# HISTORIC AND DESIGN REVIEW COMMISSION

December 15, 2021

**HDRC CASE NO:** 2021-614  
**ADDRESS:** 241 HERMINE BLVD  
**LEGAL DESCRIPTION:** NCB 9005 BLK 3 LO 71 THRU 73  
**ZONING:** R-4,H  
**CITY COUNCIL DIST.:** 1  
**DISTRICT:** Olmos Park Terrace Historic District  
**APPLICANT:** Christopher Stong  
**OWNER:** Christopher Stong  
**TYPE OF WORK:** Porch and exterior modifications  
**APPLICATION RECEIVED:** November 22, 2021  
**60-DAY REVIEW:** Not applicable due to City Council Emergency Orders  
**CASE MANAGER:** Stephanie Phillips

The applicant is requesting a Certificate of Appropriateness for approval to construct a porch overhang over the front entryway of the primary structure.

Plan

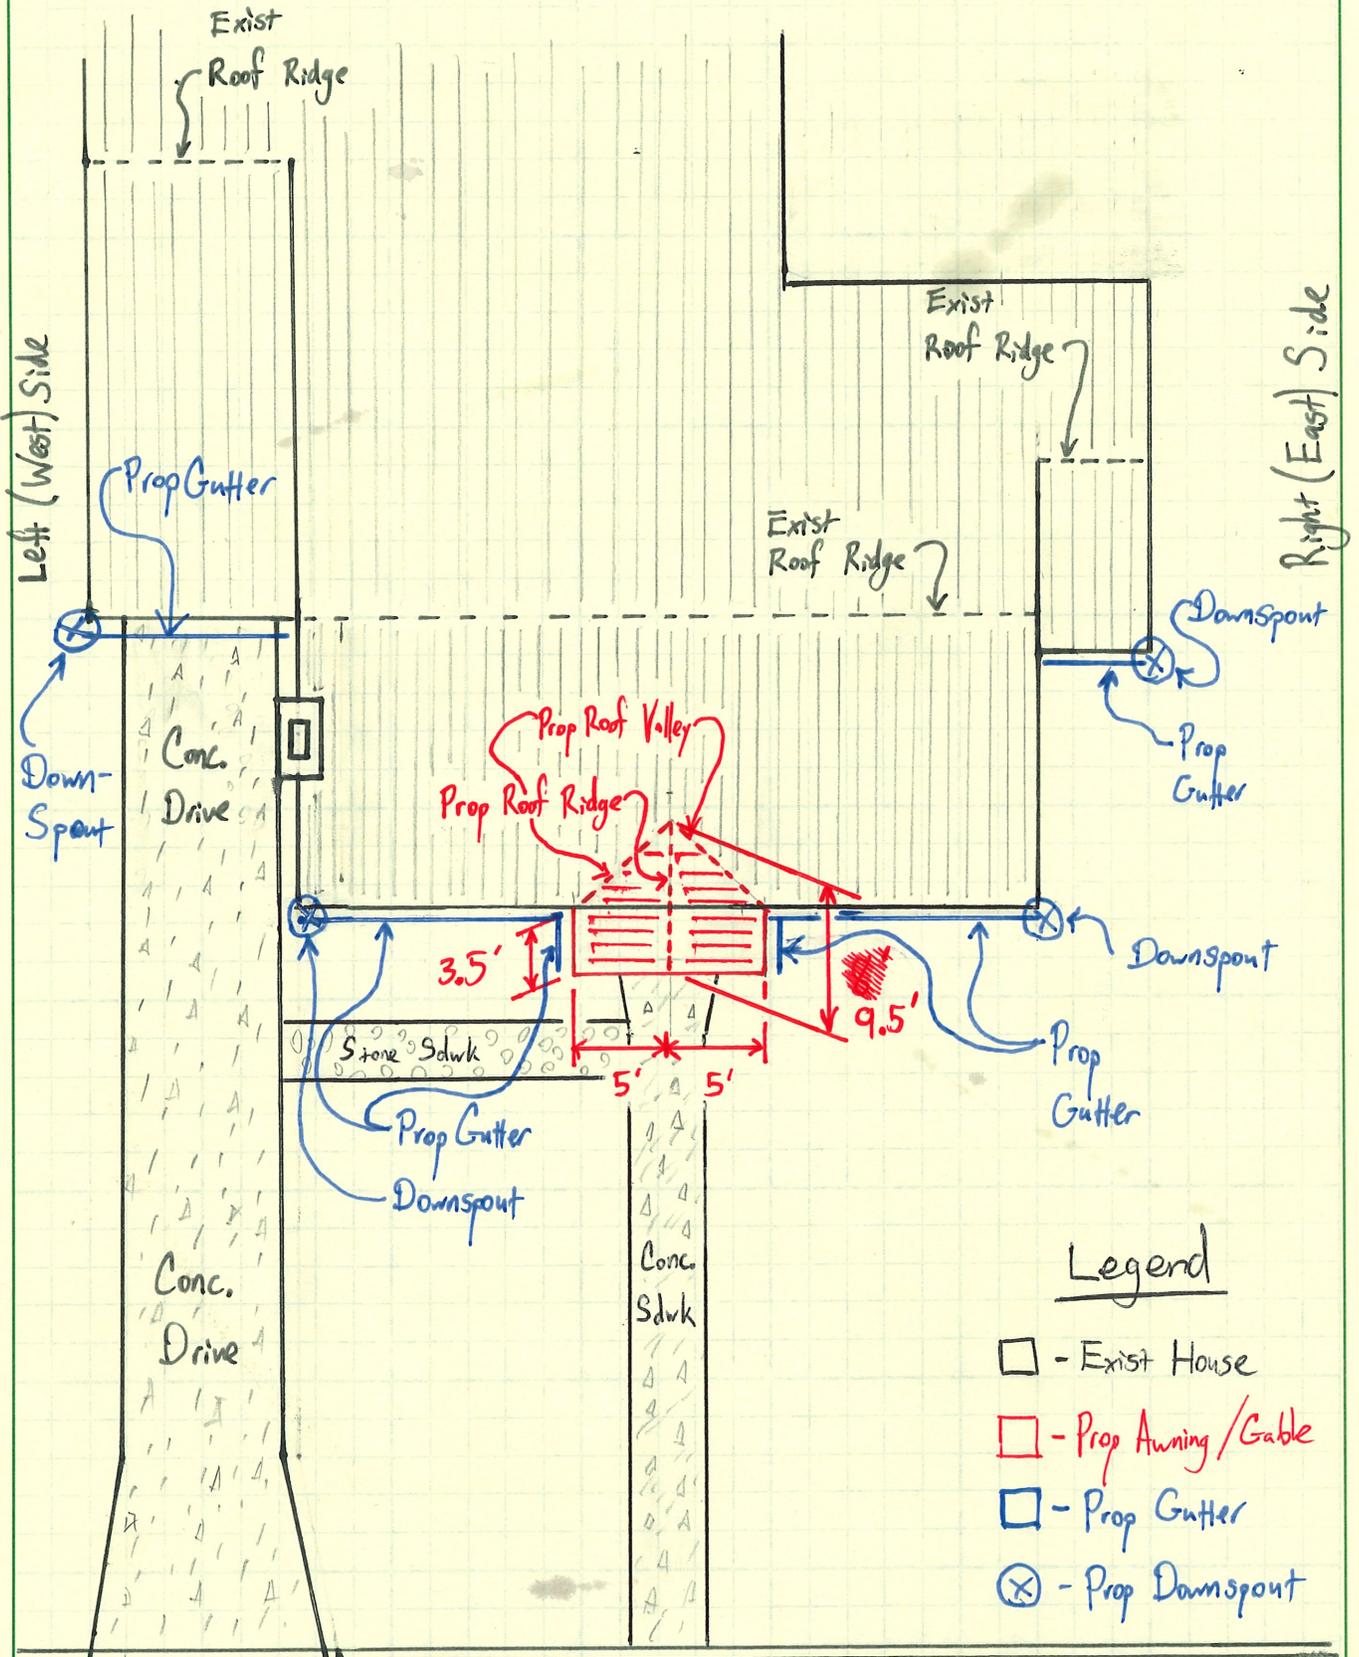
- b. **PORCH MODIFICATIONS** – The applicant has proposed to install a new porch overhang with simple gable form. A porch is not historically present; however, the footprint is minimal and only occupies the ground area of the staircase, while the porch cover adds function of water dispersion above the main entryway. The Guidelines for Exterior Maintenance and Alterations 7.B.iv. note that porch elements should not be added that create a false historic appearance, and new porch elements should not obscure or remove character defining features. Staff generally finds the proposal to be appropriate based on the overall design and added function of water dispersion above the main entryway. The installation should be done in a manner that original and character defining architectural details are not obscured.

- i. That the installation be done in a manner that original and character defining architectural details, including the dentil detailing above the door, are not obscured.
